ISSUE RESOLUTION STATUS REPORT

KEY TECHNICAL ISSUE: REPOSITORY DESIGN AND THERMAL-MECHANICAL EFFECTS

**Division of Waste Management
Office of Nuclear Material Safety and Safeguards
U.S. Nuclear Regulatory Commission**

Revision 3

Figure 16. Simulated rockfall after 100 years of thermal loading and one episode of dynamic ground motion for two slightly different fracture patterns

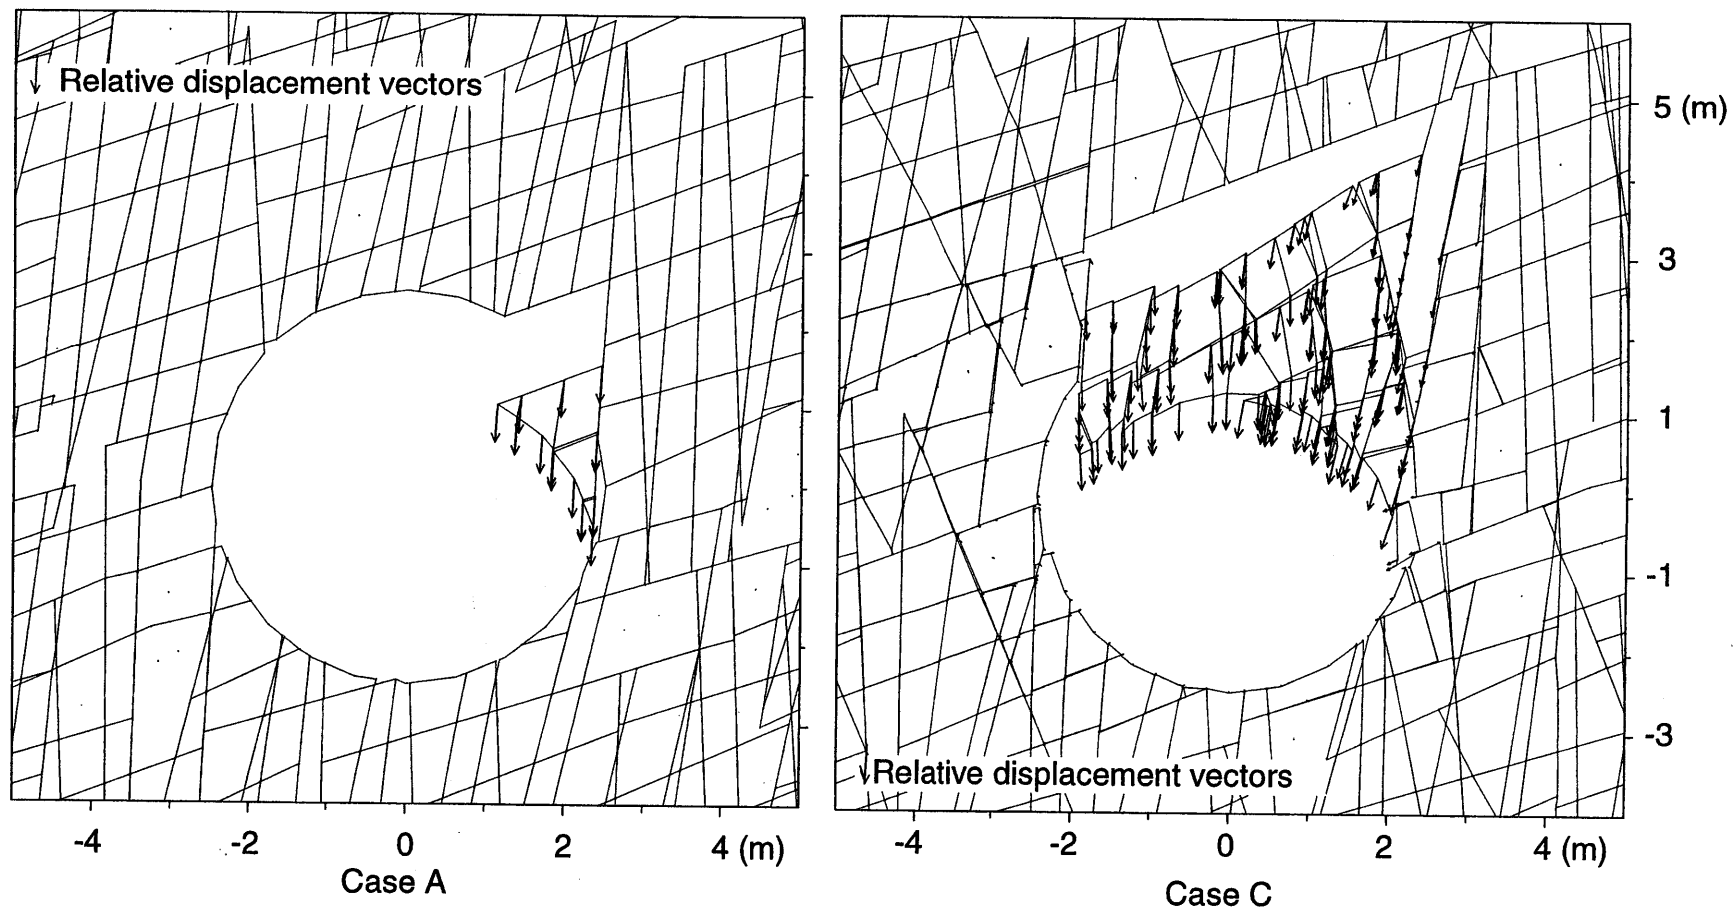
Dynamic modeling results show that of all these factors, fracture pattern may have the most significant effect on rockfall. Therefore, analyses using a regular fracture pattern such as the one shown in Figure 16 may not be conservative. An ongoing effort at CNWRA is to simulate fracture network patterns representative of the *in situ* conditions based on mapping and scanline data from the ESF and Cross Drift. Future dynamic analyses will incorporate more realistic fracture patterns and recent changes in DOE repository design.

Figure 19. Damage level versus peak ground velocity

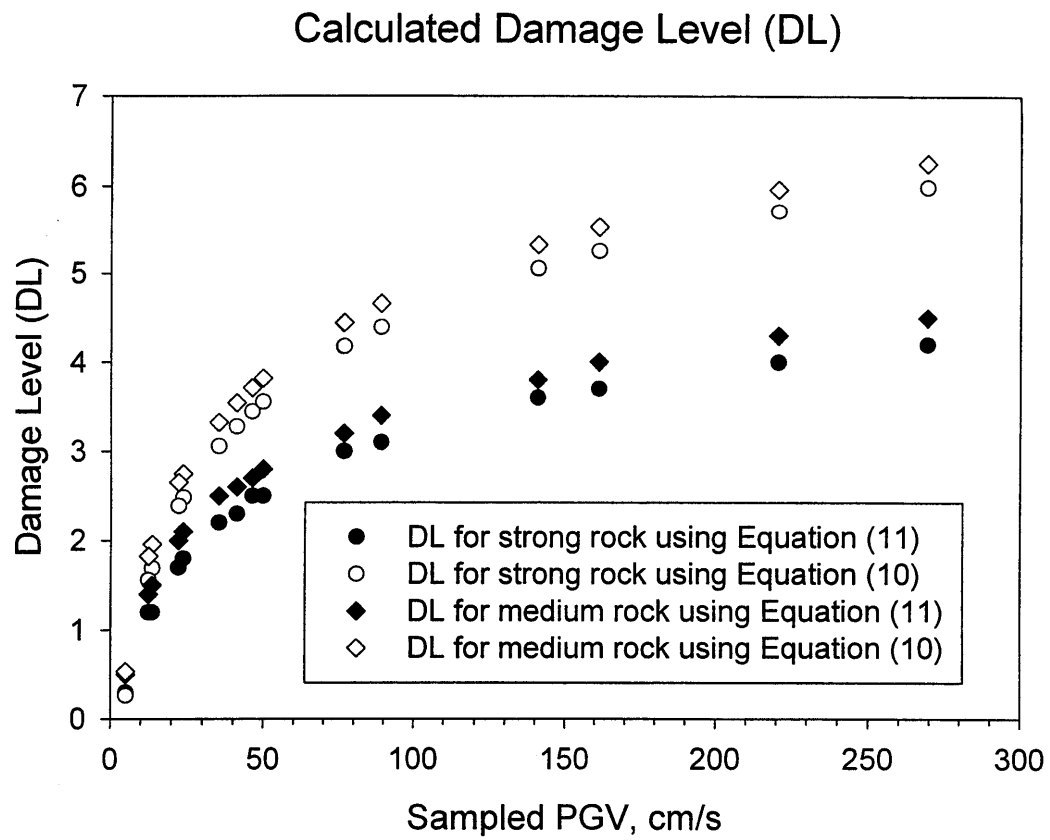
Figure 19 graphically shows the difference of *DL* values calculated for various peak ground velocity (PGVs) using these two equations. The calculated *DL* value is about 40 percent smaller for strong rock and about 30 percent smaller for the medium rock if Eq. (11) is used. It is not clear which equation was intended to be used in the TBD. If Eq. (11) is the correct equation, DOE needs to provide justification. If the use of Eq. (11) is a mistake, this mistake needs to be corrected and the rockfall effect on WP damage reevaluated.
